Access Compliance Report

Public Rights-of-Way

Intersection ID: 52289	Main Street: GANNON_DR	Cross Street: DIXIE_RIVER_RD	Location: W
ADA ID: 54764514C883	Ramp Type: Perp	Initial Pass/Fail: Fail	Overall Compliance: No
Codes/Mitigation Info/Possible Solution		Field Measurements/Component Compliance	
Severity Score: 21.25

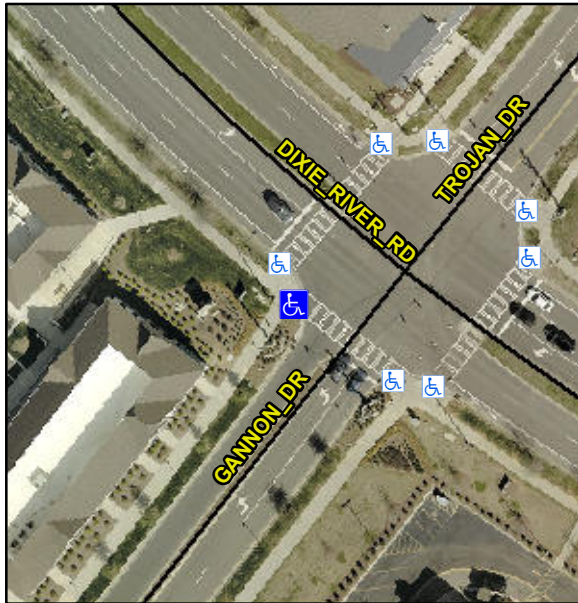
Not Found, R304.5.1, R304.5.3

Compliance	Description	Data	Compliance	Description	Data
N/A	Ramp Length (in)	98.0	Yes	Ramp Slope (%)	6.7
No	Ramp Width (in)	44.5	No	Ramp XSlope (%)	5.1
N/A	Flare Type LT	N/A	N/A	Flare Type RT	N/A
N/A	Flare Slope LT (%)	N/A	N/A	Flare Slope RT (%)	N/A
N/A	Flare Traversable LT?	N/A	N/A	Flare Traversable RT?	N/A
N/A	Landing Length (in)	N/A	N/A	DWS Provided?	N/A
N/A	Landing Width (in)	N/A	N/A	DWS Contrast?	N/A
N/A	Landing Slope (%)	N/A	N/A	DWS Length (in)	N/A
N/A	Landing X Slope (%)	N/A	N/A	DWS Full Width?	N/A
N/A	Landing Curb? (Y/N)	N/A	N/A	DWS Offset (in)	N/A
N/A	Shared Landing?	N/A			
N/A	Gutter Ponding?	N/A	N/A	Gutter Slope (%)	N/A
N/A	Gutter Lip Ht (in)	N/A	N/A	Gutter X Slope (%)	N/A
N/A	Painted X Walk1?	Yes	N/A	Painted X Walk2?	N/A
	X Walk 1 Direction	To SE		X Walk 2 Direction	N/A
N/A	X Walk 1 Width (in)	116.0	N/A	X Walk 2 Width (in)	N/A
	X Walk 1 Slope (%)	4.2		X Walk 2 Slope (%)	N/A
	X Walk 1 X Slope (%)	0.8		X Walk 2 X Slope (%)	N/A

Remove & Replace Entire Ramp.
